DOCUMENT 00 91 13.3
ADDENDUM NO. 3

RE: Wellington City – Administration and Emergency Services Building
Project No. 2509-014

FROM: Jones & DeMille Engineering, Inc. & Campbell Architecture
1675 South Highway 10
Price, UT 84501

DEMOLITION PLAN
C-101

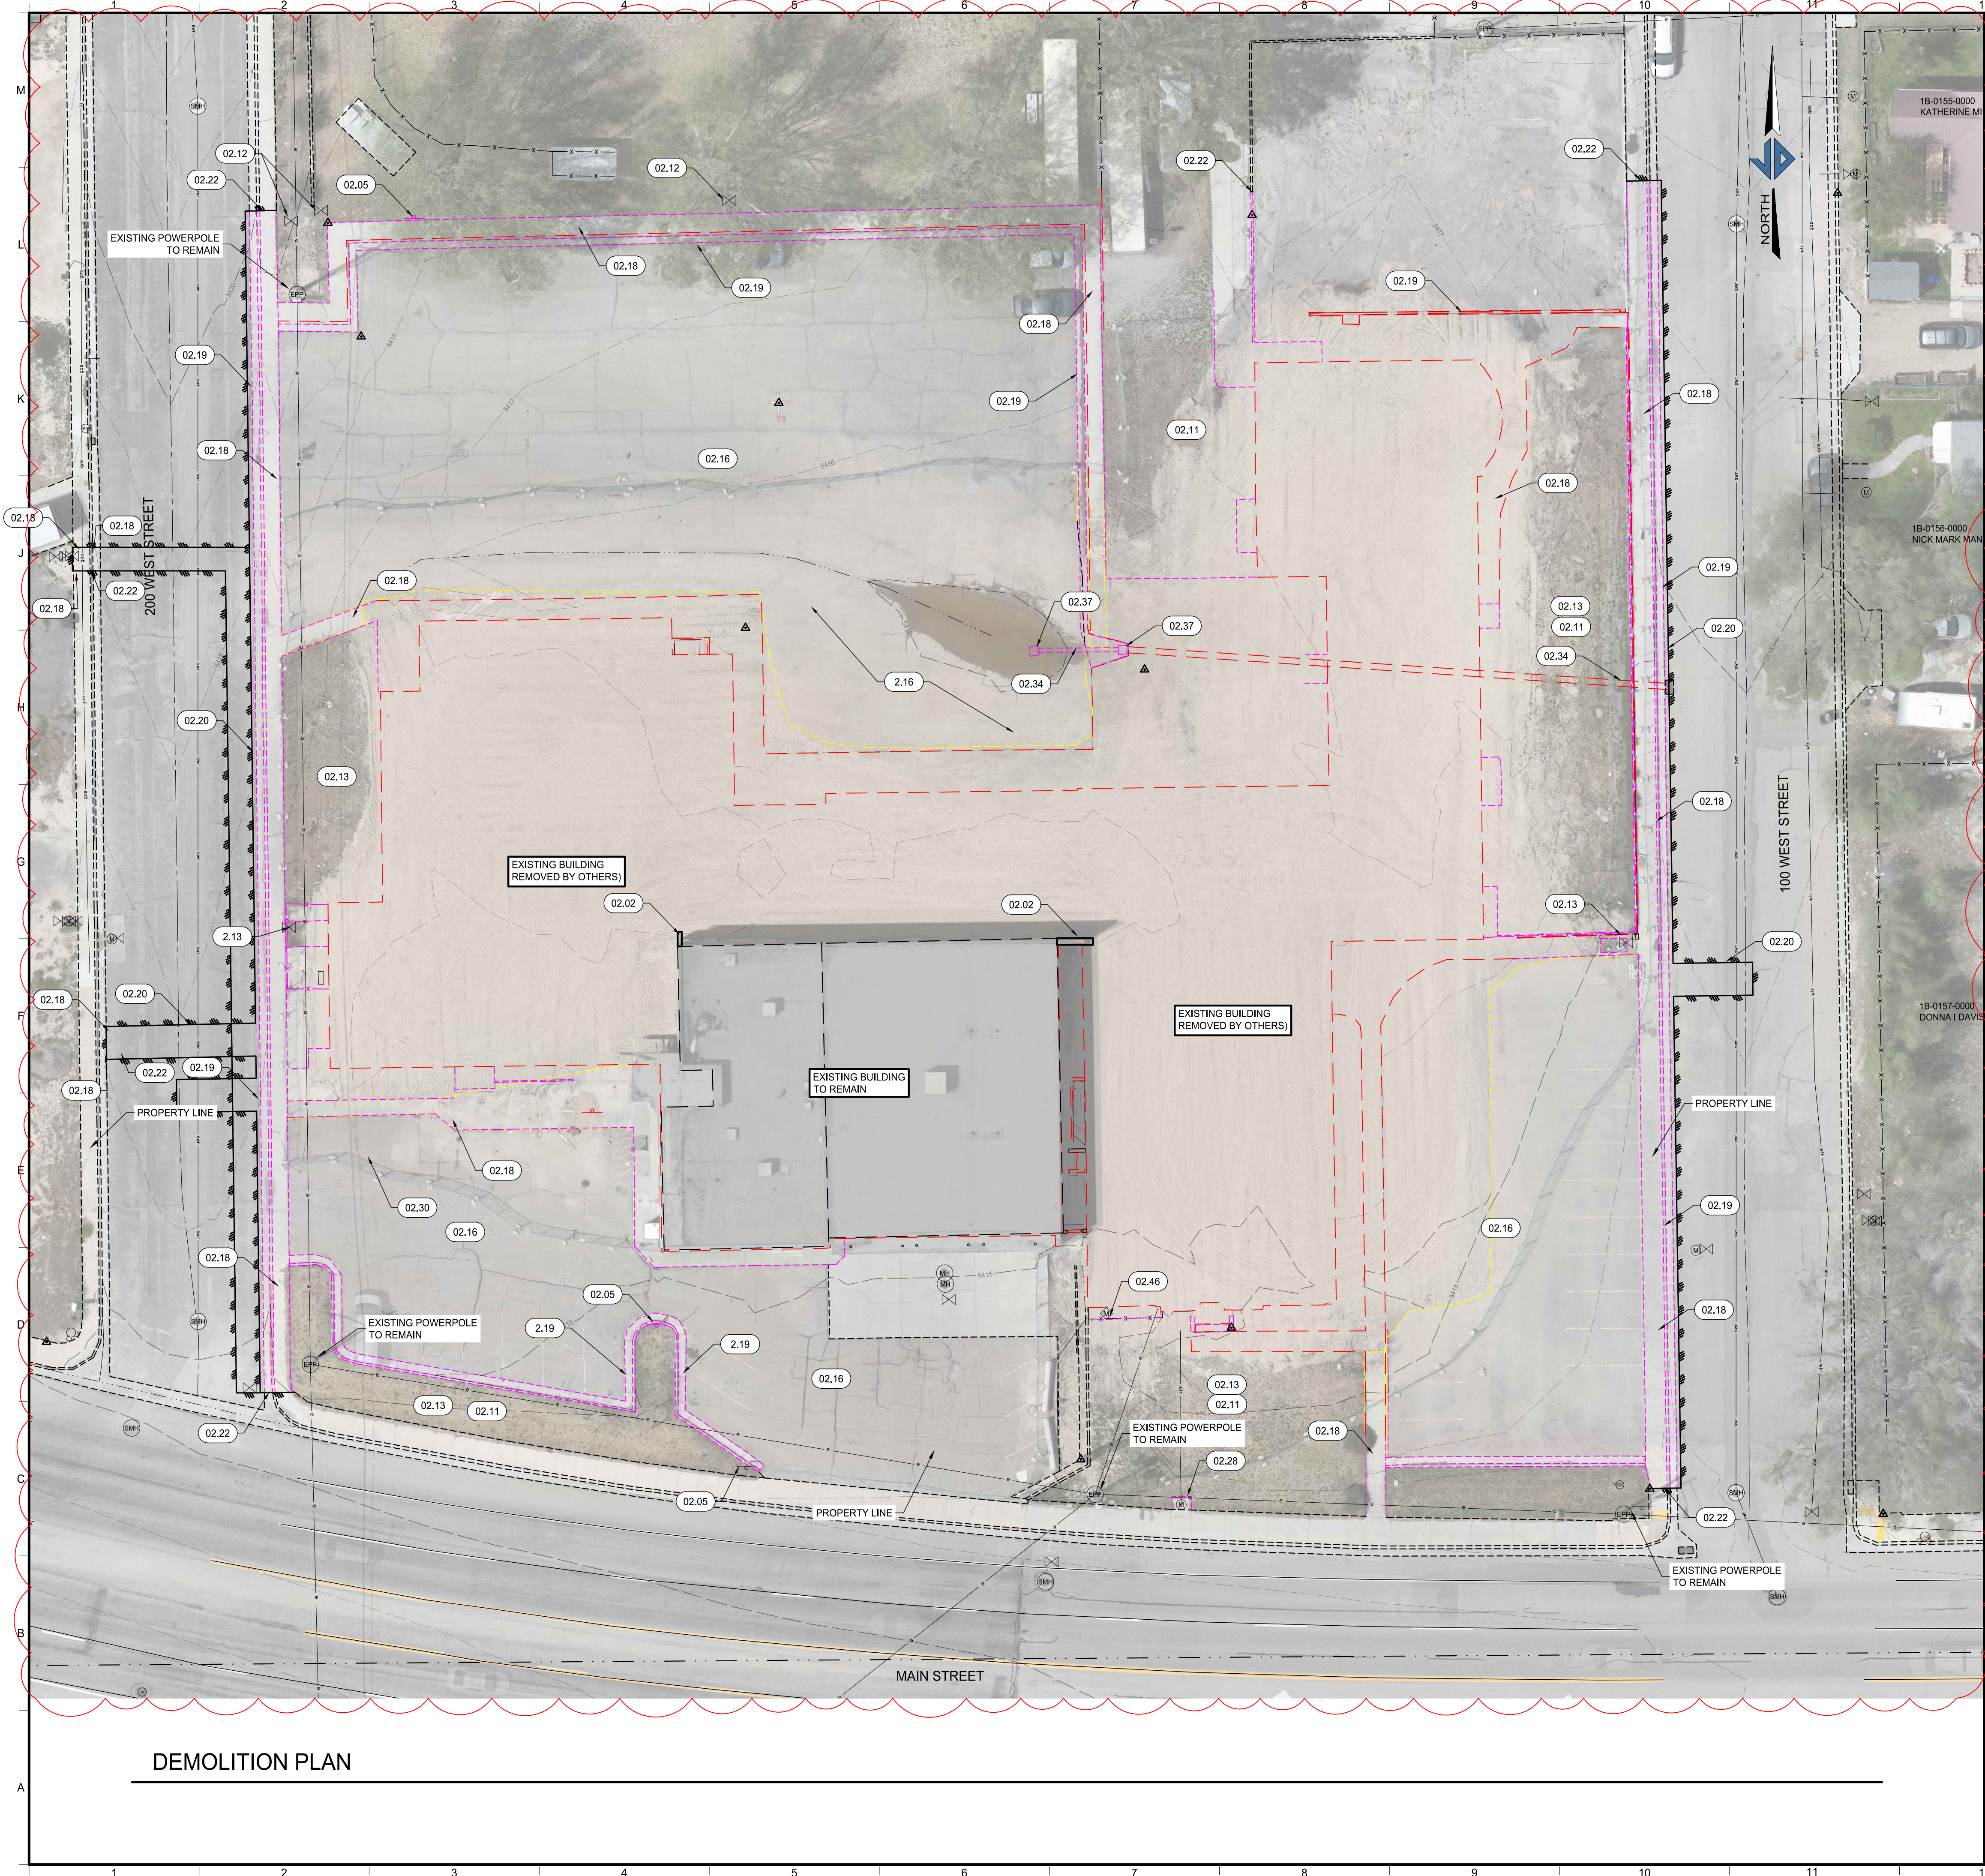
5. Sheet C-101, keynote table updated to include missing keynote line items.
6. Sheet C-201, keynote table updated to include missing keynote line items. Adjusted note wording for clarification on which details are APWA.
7. Sheet C-301, keynote table updated to include missing keynote line items. Adjusted note wording for clarification on which details are APWA.
8. Sheet A-301, Added section detail in section 2, Additional information added to Detail 3

3 FD SOFFIT TERMINATION BAR
1 1/2" = 1'-0"

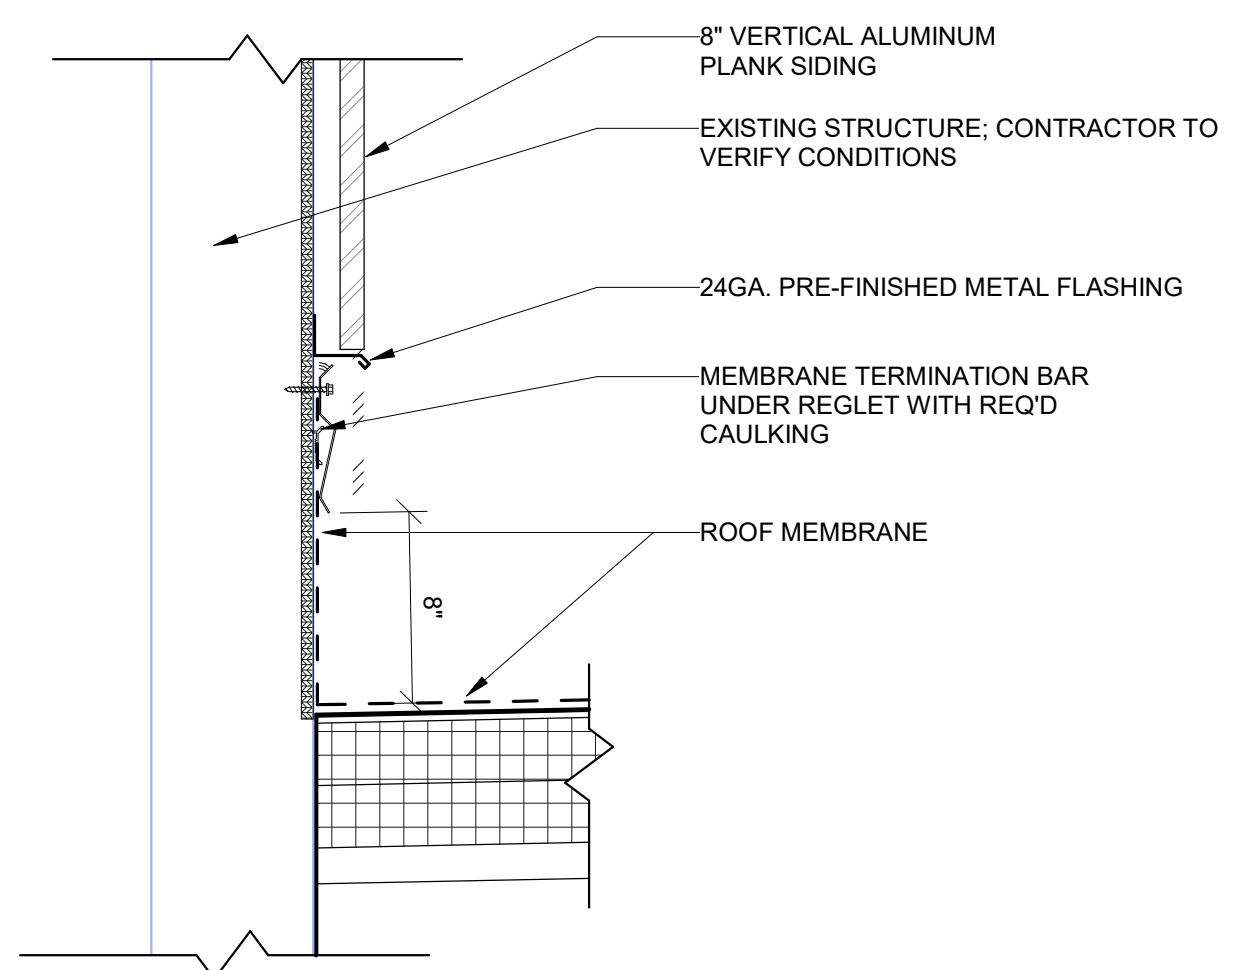
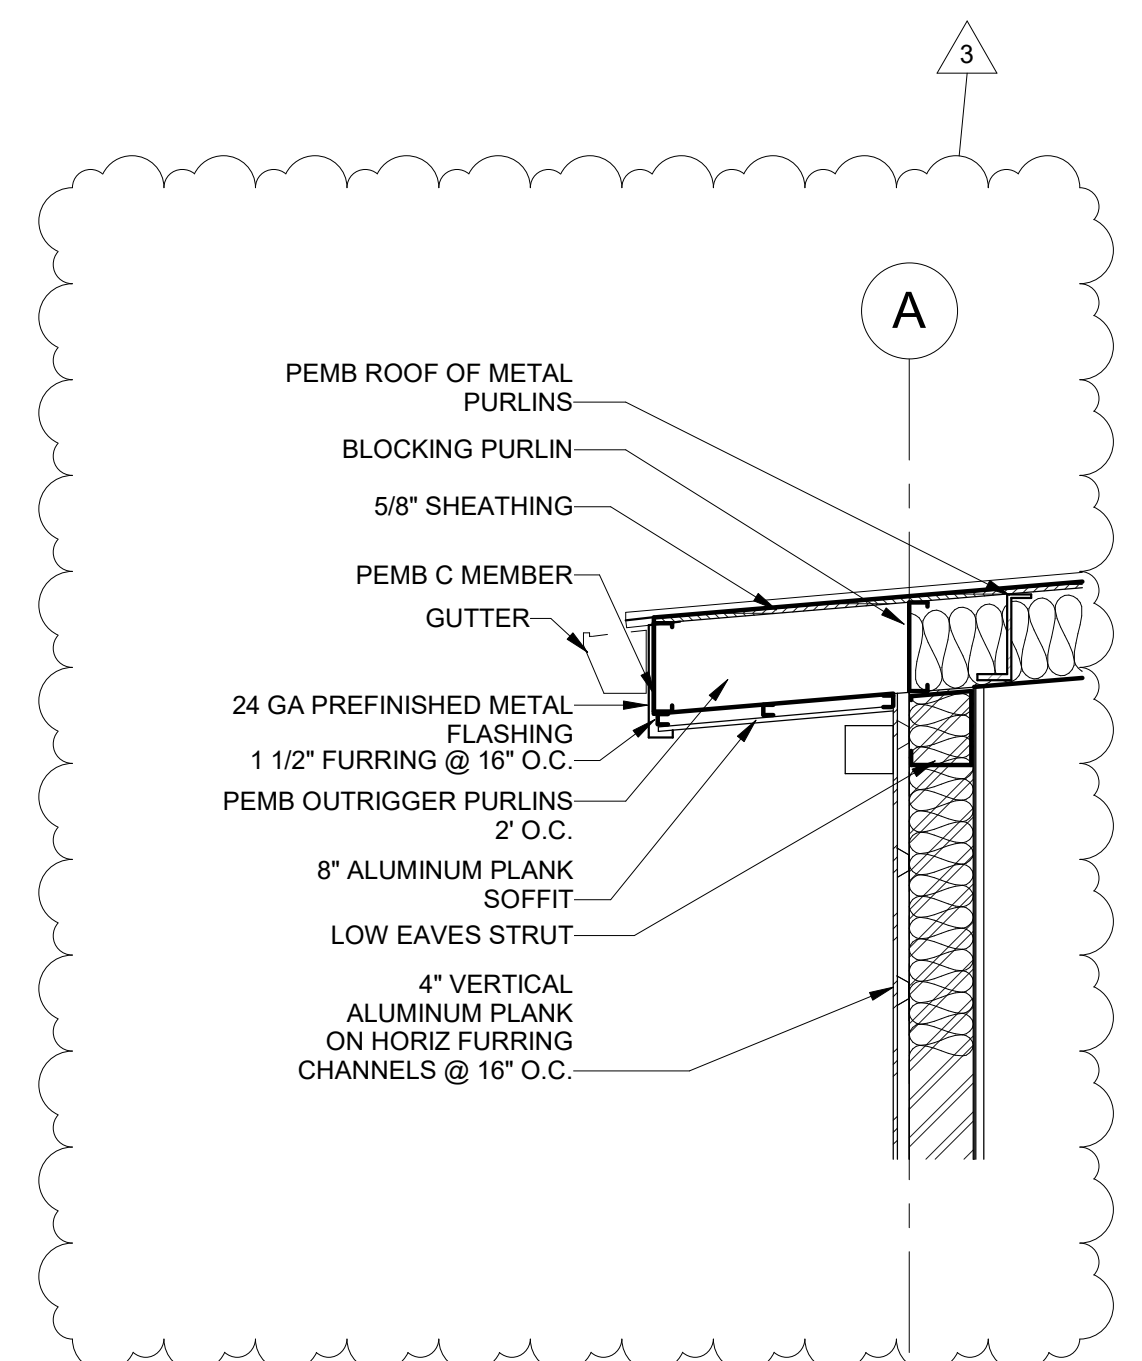
- 9. Sheet A-312, Clarification added to detail 5
- 10. Sheet A-313, Detail 5 added
- 11. Sheet A-601, Door Schedule updated
- 12. Sheet E-111, Keynote 4 revised
